Whitehorse City Council submission

Suburban Rail Loop Draft Precinct Visions – Box Hill and Burwood

February 2024

4 Opportunity Areas, source: Suburban Rail Loop East, Draft Precinct Vision - Burwood, 2023

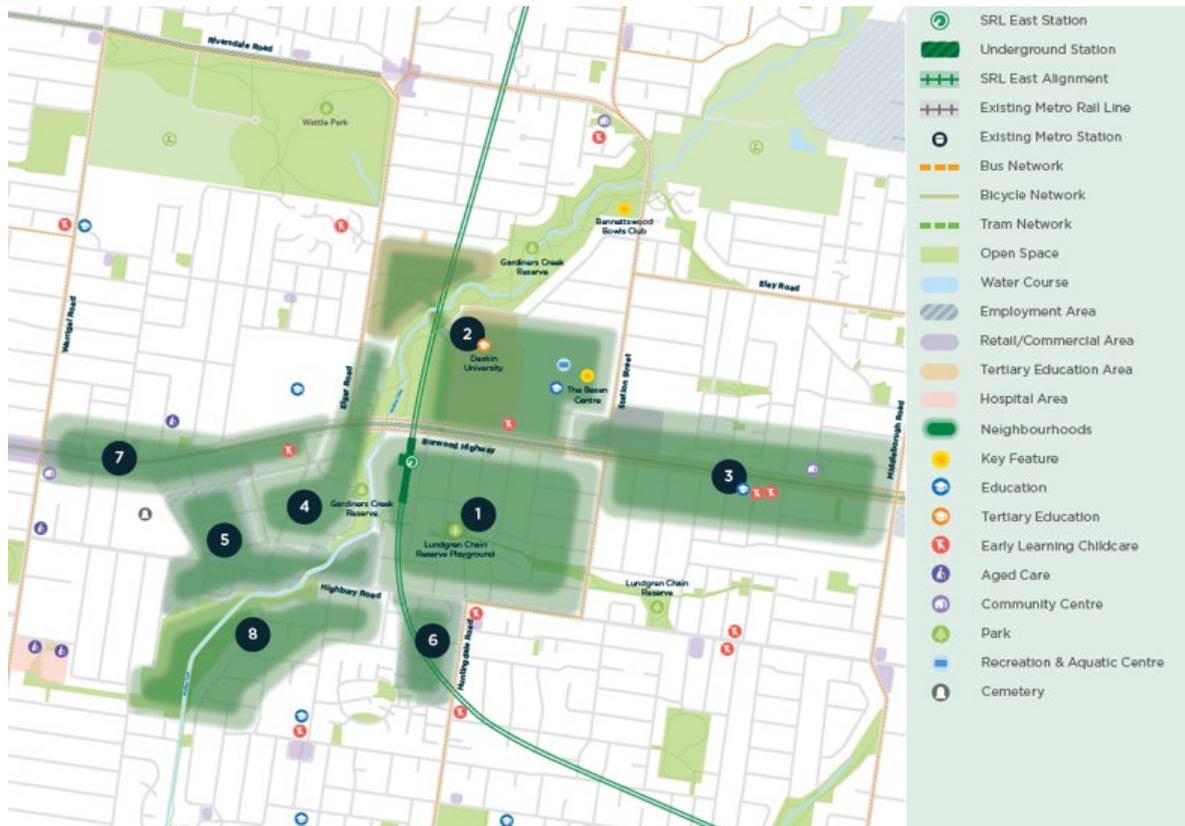
Opportunity area	Whitehorse City Council comments
1. New Burwood central area	<p>The Draft Vision document correctly identifies that this area is currently typified by low rise detached dwellings, and therefore Council queries the extent and type of growth expected in this area.</p> <p>Council is not supportive of this location as the central activity area with the level of change across the neighbourhood depicted on the Draft Precinct Plan. Beyond the land included in the RGZ along the Burwood Highway corridor it quickly transitions to traditional residential development. The <i>Whitehorse Residential Corridor Study</i> recognises increased development along the corridor but aims to protect the lower density development in the corridor hinterland.</p> <p>Whilst it anticipates that this area will benefit from being highly accessible to the SRL station, it does not acknowledge that Lundgren Chain is disconnected from the SRL station at its closest point unless there is property acquisition to connect it.</p>

2. Central Campus	<p>Council supports the growth of the education precinct, centred around Deakin University and better activation of the University to Burwood Highway. However, Council queries the inclusion of the Mount Scopus Memorial College site as previously discussed. The precinct planning should not hinge on the future potential relocation of the College, given this is not guaranteed.</p> <p>What does “diverse” accommodation mean in the context of this neighbourhood? Is it student housing, affordable housing and /or diversity of dwelling typologies? Council notes that the development of purpose built student accommodation has declined in favour of standard apartments suitable for student rental.</p>

5. Burwood Economic Cluster	<p>Council supports this opportunity area, but as above further analysis needs to be undertaken about the demand for industrial land uses in the area. Council seeks to protect the limited industrial areas in the municipality; therefore, the structure plan needs to be clear about what activity will be supported in this precinct.</p> <p>This neighbourhood should recognise the need for better and clearer connection to the SRL station.</p>

6. Highbury Enterprise Precinct	<p>Council supports the opportunity to align new local enterprises, startups, and incubator spaces with Deakin University. The planning of this precinct requires collaboration between Whitehorse Council, Monash Council and the SRLA.</p>

<p>7. Burwood Highway West</p>	<p>Council supports the growth of the corridor to the west but queries the termination of the neighbourhood at Warrigal Road. Council suggests the SRLA consider the merit for continuation of the corridor as more holistic and strategic planning exercise, particularly given this strip shopping centre already exists with a relatively strong commercial viability. The boundary of the SRL precinct structure planning should not occur based on administrative or political boundaries (such as a municipal boundary or electorate boundaries).</p> <p>Council queries the depth of this corridor beyond Burwood Highway and the extent of the growth expected, particularly given the location of heritage overlays and the design and development overlays, but notes that it seems deliberately narrower than Opportunity Area 3 that extends to the east. Council would like to understand the rationale.</p> <p>There is limited information for this Opportunity Area which does not allow more detailed feedback.</p>

7 Opportunity areas, source: Suburban Rail Loop East, Draft Precinct Vision - Box Hill, 2023

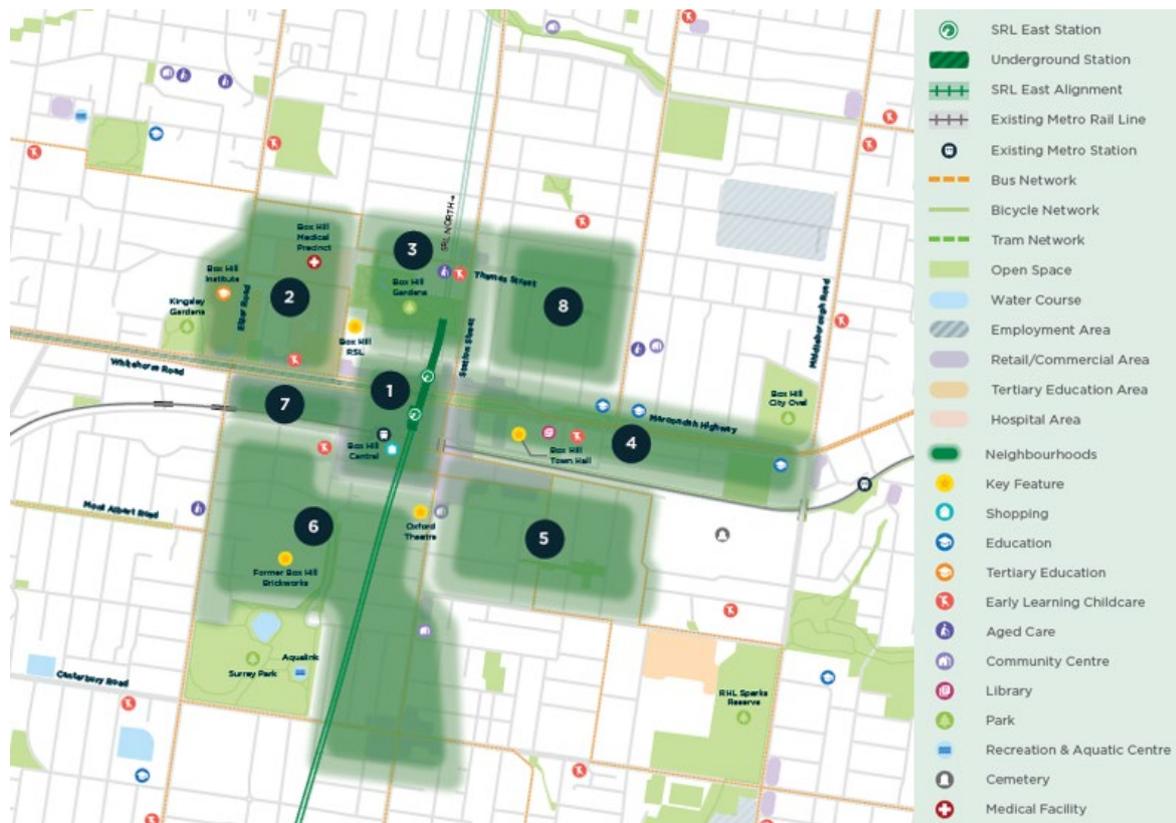
- Reference has already been made that the symbols/ features on this map are difficult to read and we query the locations. Specific to this plan, Council seeks clarification of the “Key feature” symbol and what this means. In addition, should the previously referenced potential “landmarks” be shown?
- The Retail/commercial, Tertiary/education and Hospital areas are not clearly highlighted.
- Text on the map is often concealed affecting readability.

3. Box Hill Gardens	<p>This opportunity area reflects Precinct 4: Garden Neighbourhood of the BHSP and is supported, particularly the retention of a significant contribution to open space and recreation within the Metropolitan Activity Centre.</p> <p>However, Council reiterates its concerns about the lack of open space in the area and the lack of acknowledgement that there will be impacts on the Box Hill Gardens due to its use as a temporary construction site for a significant portion of the life of the Structure Plan. The opportunity area supports new medium and higher density housing to allow more residents to access the Gardens as open space, therefore increasing the significant shortfall of open space available per person. The Structure Plan therefore cannot rely on Box Hill Gardens to provide the open space needs to the increasing population – it must plan for new open spaces in addition to the temporary spaces planned as offsets for the use of Box Hill Gardens.</p>

4. Civic Precinct and Whitehorse Road East	<p>This opportunity area reflects Precinct 5: Civic and Cultural Neighbourhood of the BHSP and is supported, however Council queries the extent of the area, particularly the location of medium scale office development towards Middleborough Road.</p> <p>Council is concerned about Laburnum Station being included in this area (or indeed the precinct planning process) as it offers different characteristics than the Box Hill Metropolitan Activity Centre. The boundary should be Middleborough Road.</p> <p>Enhancements are needed to support Whitehorse Road as “a major pedestrian-focussed boulevard linking compact [sub] neighbourhoods between Box Hill High School and central Box Hill.” The avenue mature trees are a feature of this corridor to enhance however the paths could be improved.</p>

5. Ellingworth Enterprise District	<p>The concept of this opportunity area reflects Precinct 6: Enterprise Neighbourhood of the BHSP and is supported, particularly as a location for small lot employment uses that could accommodate start up, innovative and flexible workspaces.</p> <p>Whilst the document recognises that “<i>sensitive planning to guide a transition in the scale of development to neighbouring residential communities</i>” is required, the extent of the opportunity area is well beyond that envisaged by the BHSP and requires revision.</p> <p>Presumably the reference to this neighbourhood being “<i>well connected to jobs, ...and entertainment options</i>” means connection to these uses located in nearby neighbourhood #1. Perhaps this should be clarified.</p>
